**ADDENDUM NUMBER TWO (2)  
TO THE PLANS AND SPECIFICATIONS FOR:**

**NORTH ECHS  
AND  
COLLEGE & UNIVERSITY CAMPUS  
STUDENT RESTROOM RENOVATIONS**

**PSJA ISD  
Bid # 18-19-042  
Project No. 19.04**

**GIGNAC & ASSOCIATES  
3700 N. 10<sup>th</sup> STREET, SUITE 205  
McALLEN, TEXAS 78501  
(956) 686-0100**

2 ENLARGED MECHANICAL DEMOLITION PLAN  
MD2.12U 3/16"=1'-0"

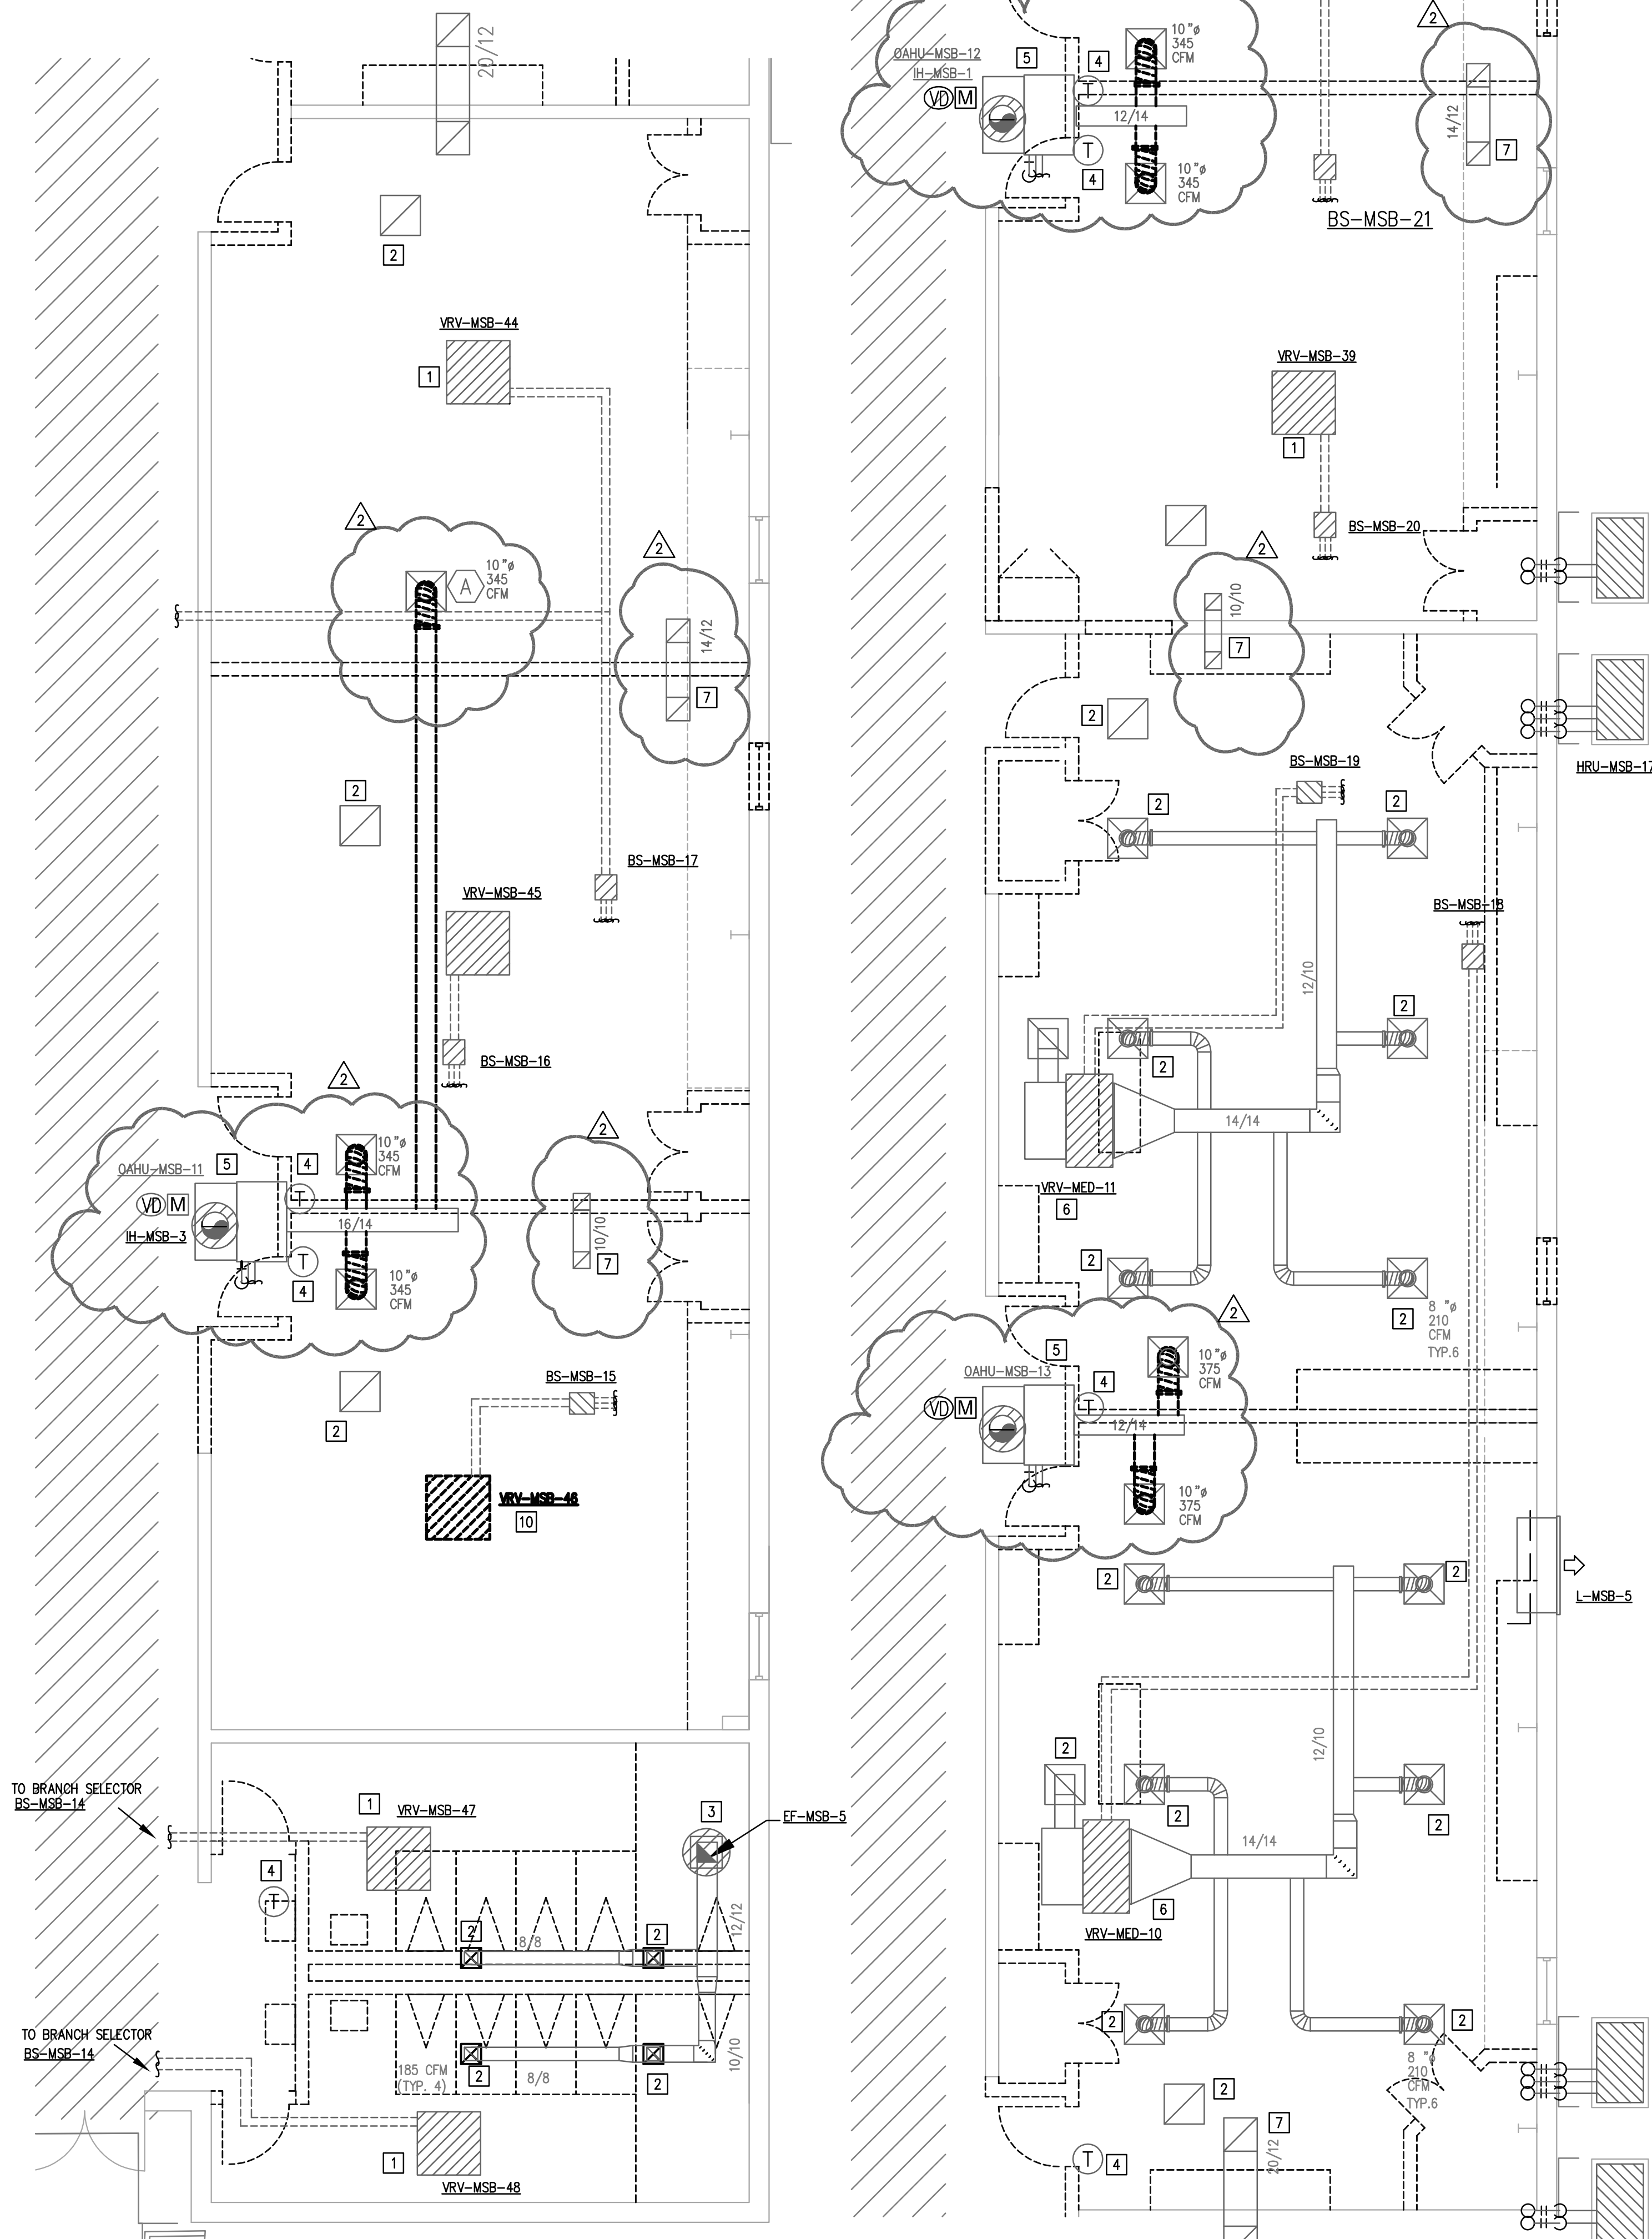
- A.      Outside air units to remain and all associated ductwork and air devices shall not be removed and noted to be relocated. Transfer ducts to be relocated. Re: MD2.12U.

EP2.12U

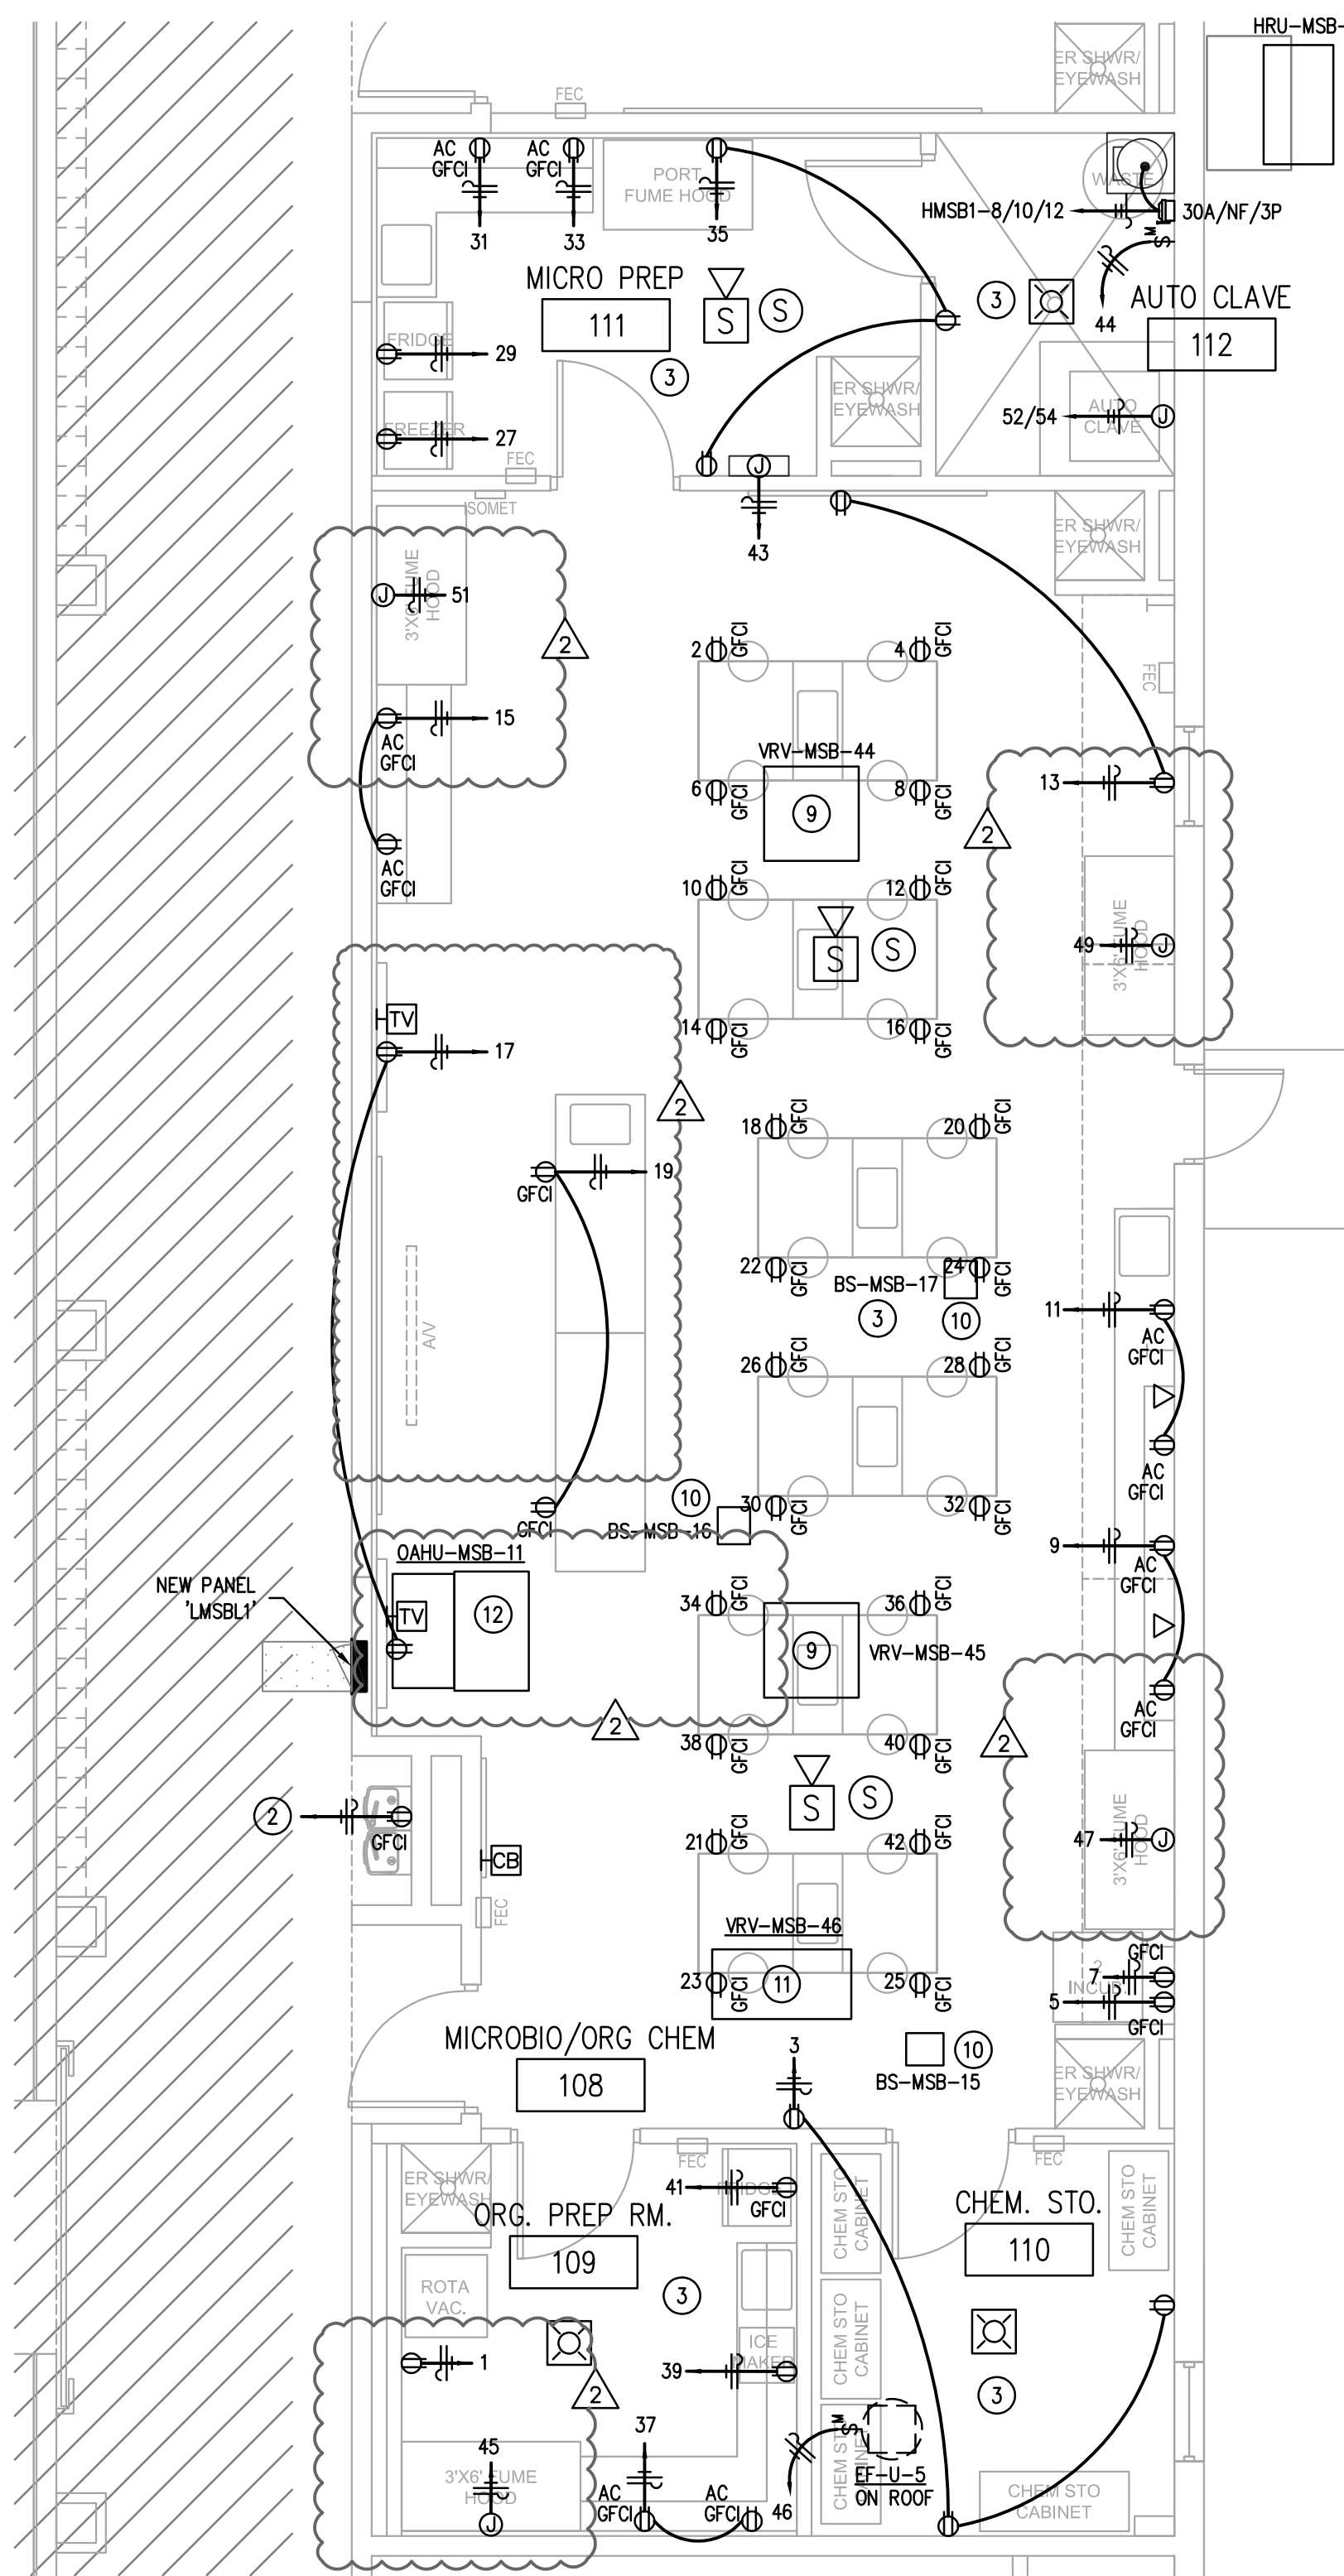
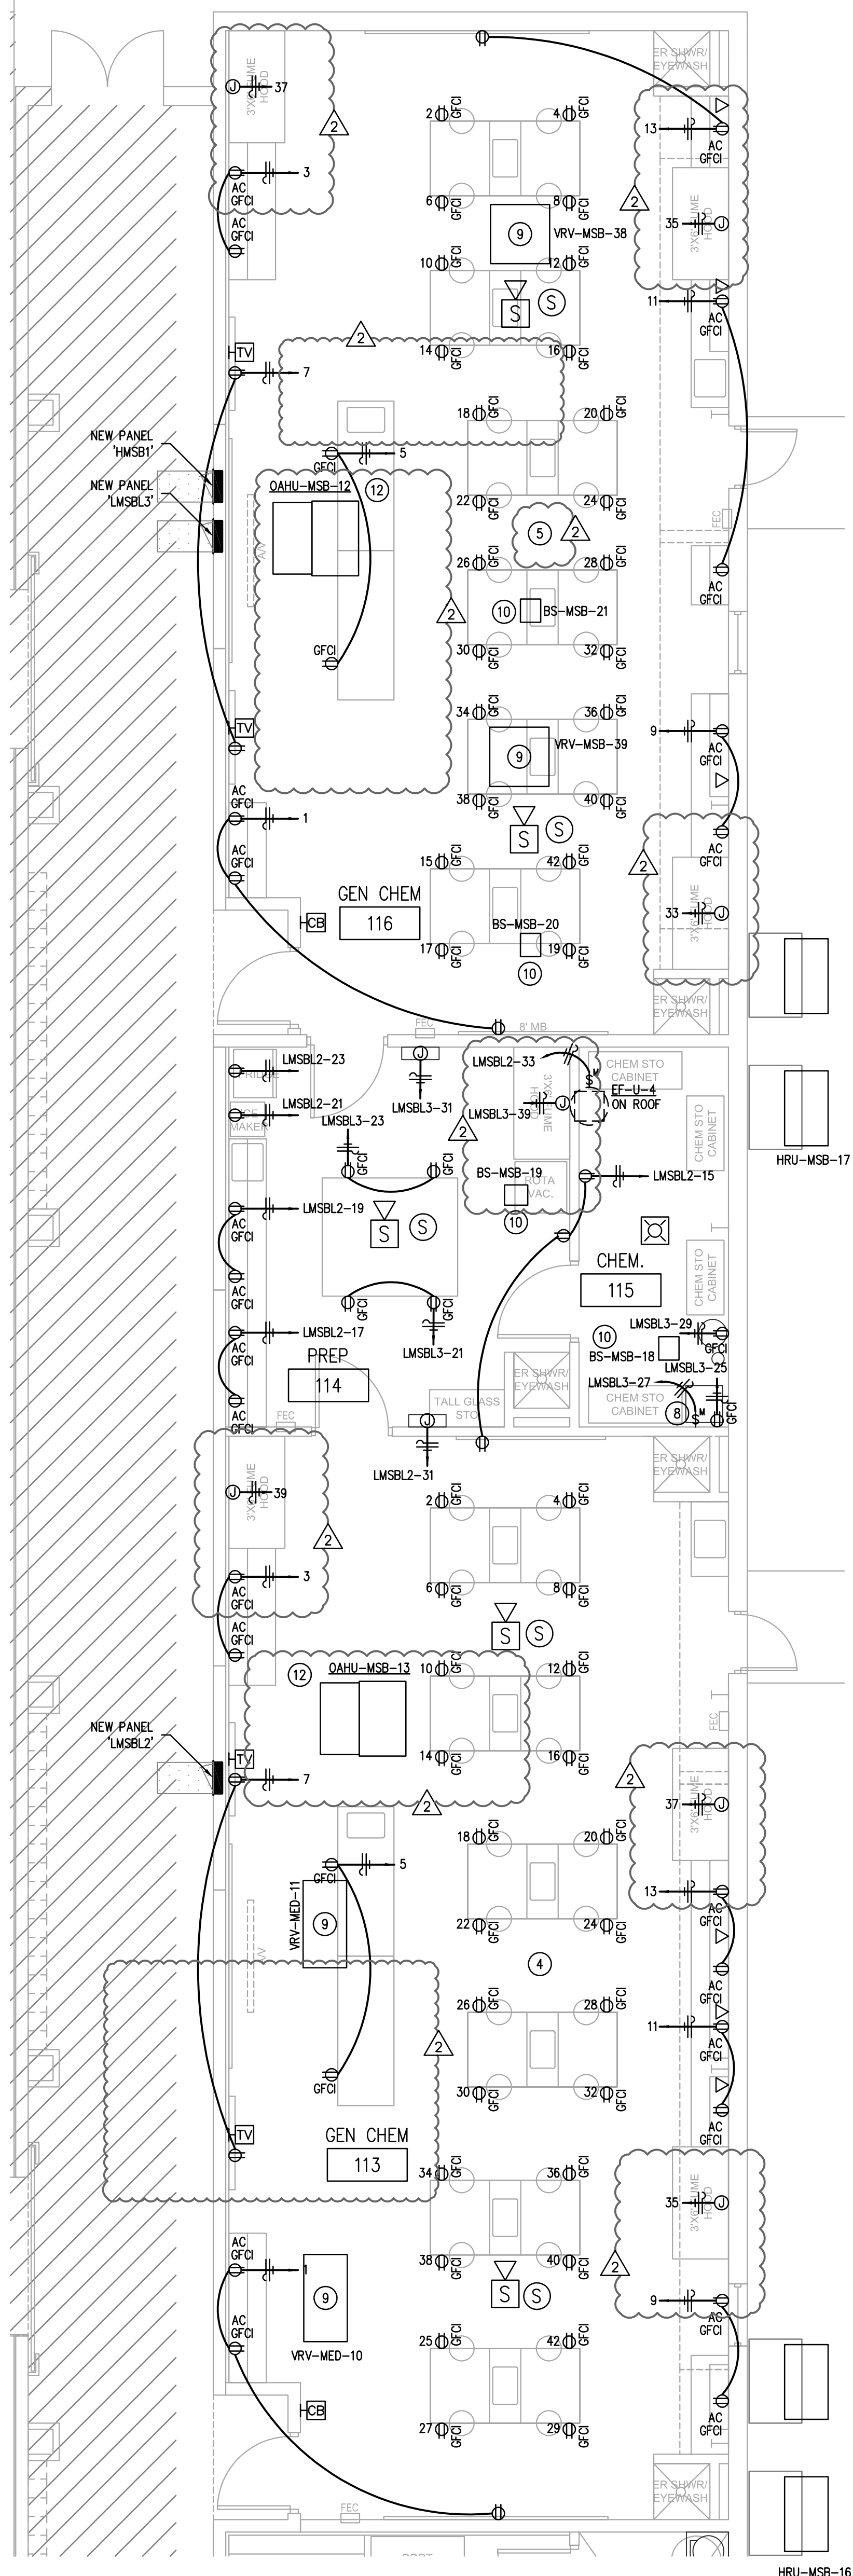
- A.      Removed electrical circuit information for roof top units. Re: EP 2.12U
- B.      Removed electrical circuit information for fume hood exhaust fans. Re: EP 2.12U
- C.      Modified electrical circuiting to lab hoods. Re: EP 2.12U
